FINAL DRAINAGE REPORT

CLAREMONT BUSINESS PARK
FILING NO. 2, LOT 2-1A

EL PASO COUNTY, COLORADO

PCD File No. PPR192
ADDED

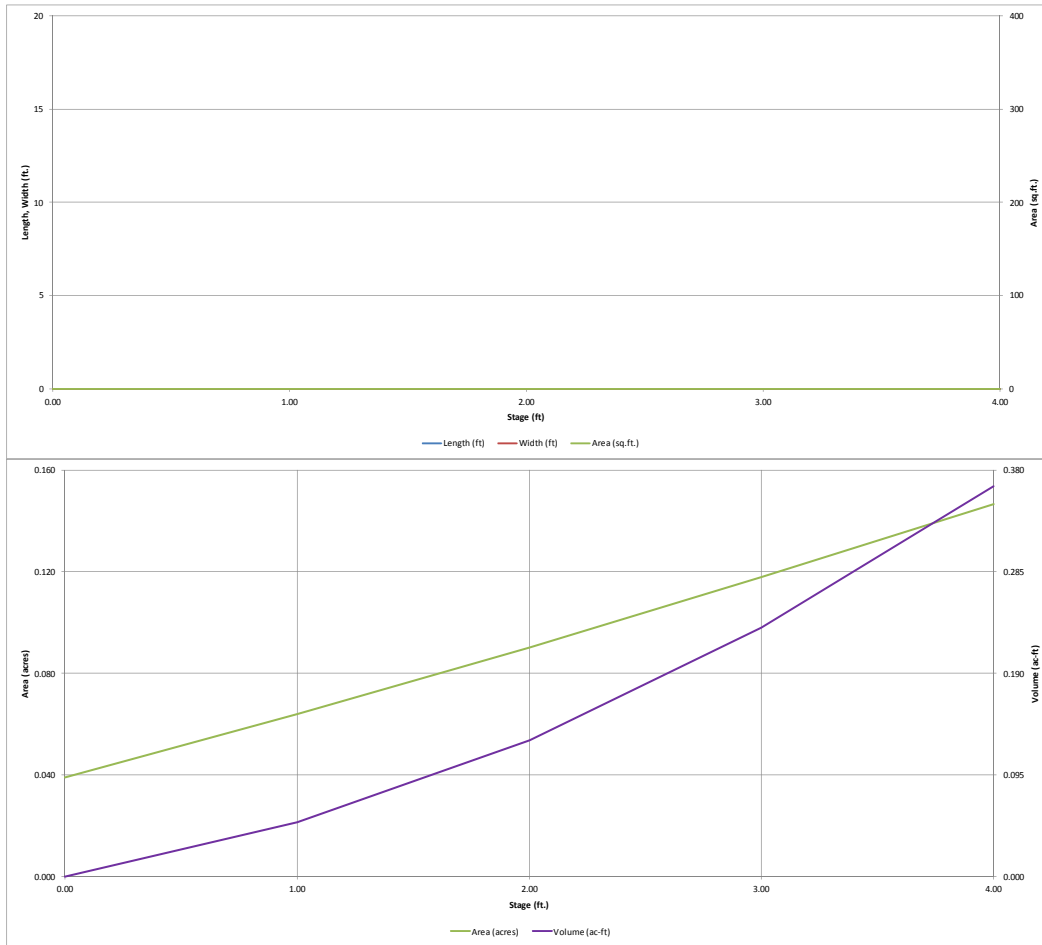
*Provide note that per Resolution 16-426 of the BoCC, on-site WQCV is required but on-site stormwater detention is not required per the FDR for Claremont Business Park Fil. 2.

SAND FILTER BASIN AND SPILLWAY DETAIL (NOT TO SCALE)

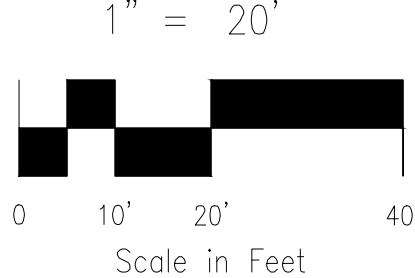
Please show building wall line. Per Urban Drainage this BMP should not be located within 10 feet of a building foundation without an impermeable membrane.

PROVIDED
Provide calculation for RipRap

GEOTEXTILE FABRIC HAS BEEN ADDED
